Critique of NYSERDA's Draft Plan

Herschel Specter

March, 2022

This document is a critique of the “New York State Climate Action Council’s Draft Scoping Plan” prepared by NYSERDA with the assistance of E3 and Abt Associates, herein called the NYSERDA Draft Plan. The major conclusions are:

6.1.1 SLIDE 42

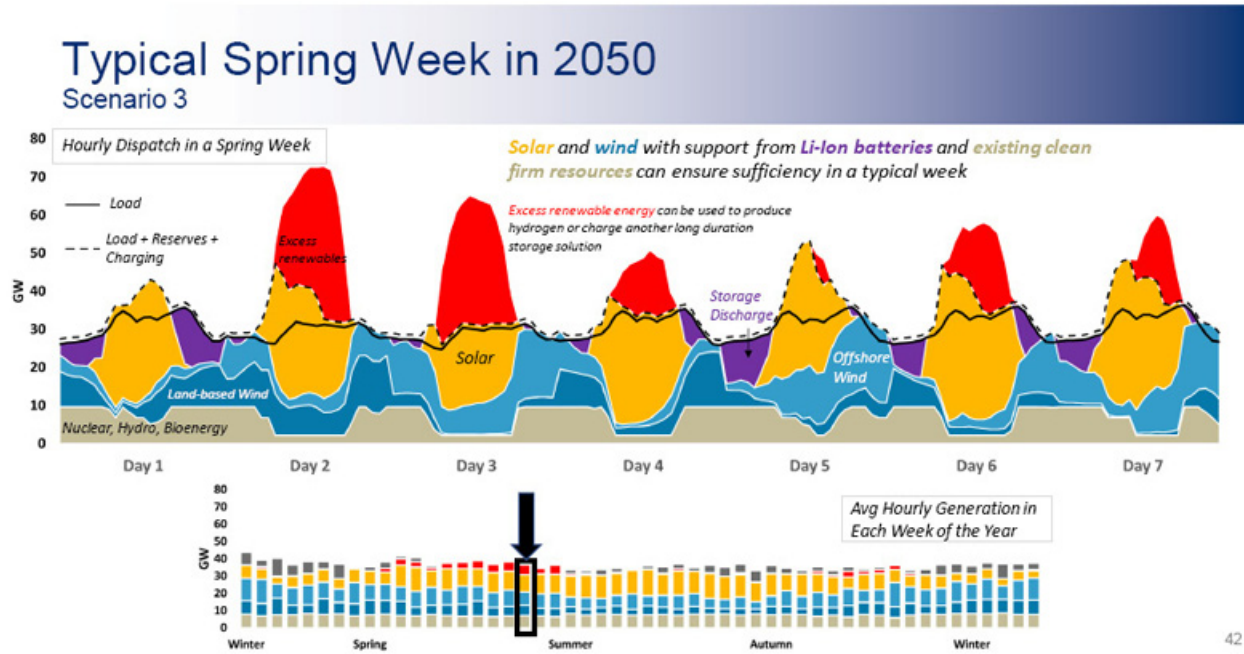
Slide 42 of the NYSERDA report shows a Typical Spring Week in 2050, as if anyone today knows what a typical spring week in 2050 might look like. This slide shows the generation of excess solar energy and has an insert stating "Excess renewable energy can be used to produce hydrogen or charge another long duration solution". **This other long duration solution in the NYSERDA report is undefined.** In slide 42 there is energy contribution from both onshore and offshore wind power. However, if there was a long duration and widespread wind lull during this warmer time period, both onshore and offshore wind contributions likely would not be available. In such a case the excess solar energy normally used to make hydrogen would, instead, have to be used to meet ongoing demands for electricity. This, in turn means that there could be insufficient long term hydrogen storage for the winter months. So a wind lull in the summer could lead to energy shortfalls the following winter. Therefore long term lulls in wind power, be they in winter or summer, could create an energy tragedy similar to what happened in Texas.

6.1.2 SLIDE 43

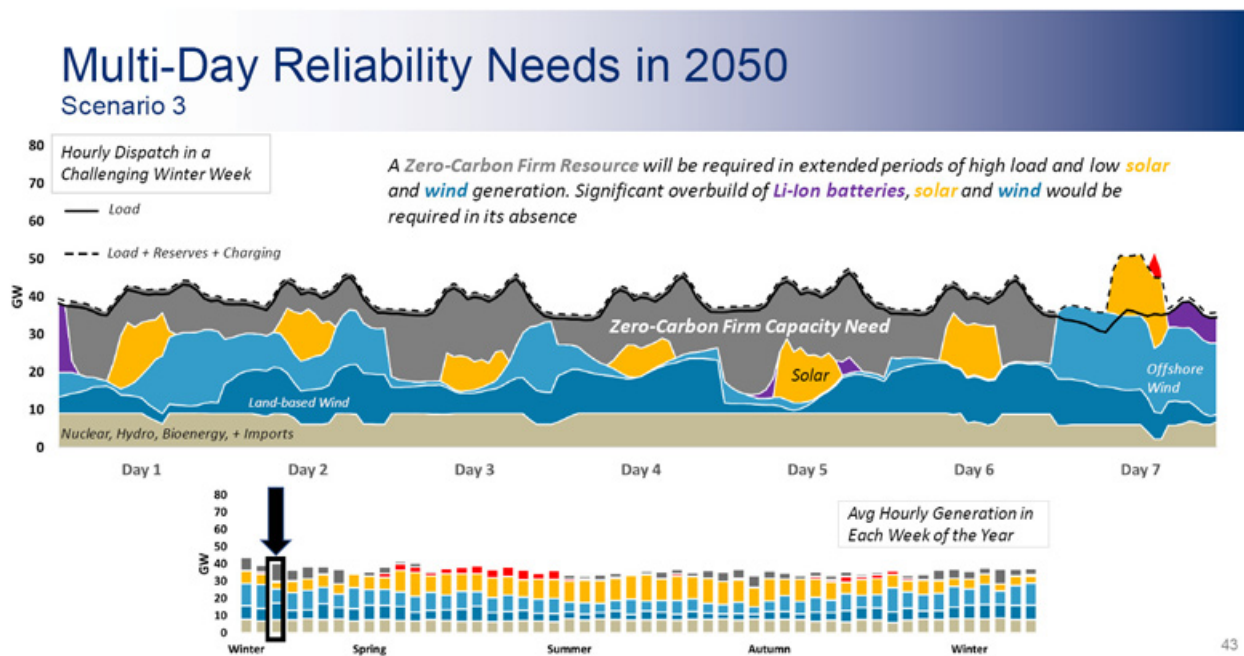
The NYSERDA report's slide 43 is incomplete. It tries to show how a single week in January might be able to meet electricity demands if it can draw upon long duration storage. But there can be other weeks in the winter which also have shortfalls in their electricity production relative to that week's demand for electricity. Even if the shortfalls in these additional weeks are not as severe as the single week selected in slide 43, they would still need to be able to draw upon long term storage. **The amount of energy needed to be generated for long term storage requires a full year's analysis, not just one week's worth.**

6.1.3 SLIDE 44

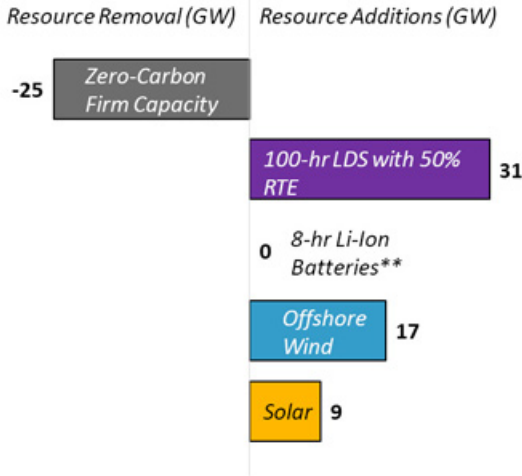
An alternative to zero carbon firm capacity is suggested in the NYSERDA report's slide 44. Here 17 more GW of offshore wind plus 9 more GW of solar are to be added to a scenario that is already overtaxed with huge numbers of solar panels and wind turbines that would have to be manufactured and installed at an unprecedented rate. The 17 GW of additional offshore wind would be useless during a widespread wind lull. The additional solar would still be subject to low

capacity factors and the very poor overall efficiency of a solar-to-hydrogen-to-electricity system. The adequacy of the 31 GW of long duration storage may not be sufficient if it is only there to handle a one week duration in winter. **Determining the capacity of long duration storage requires an analysis of a whole year's worth of storage requirements.**
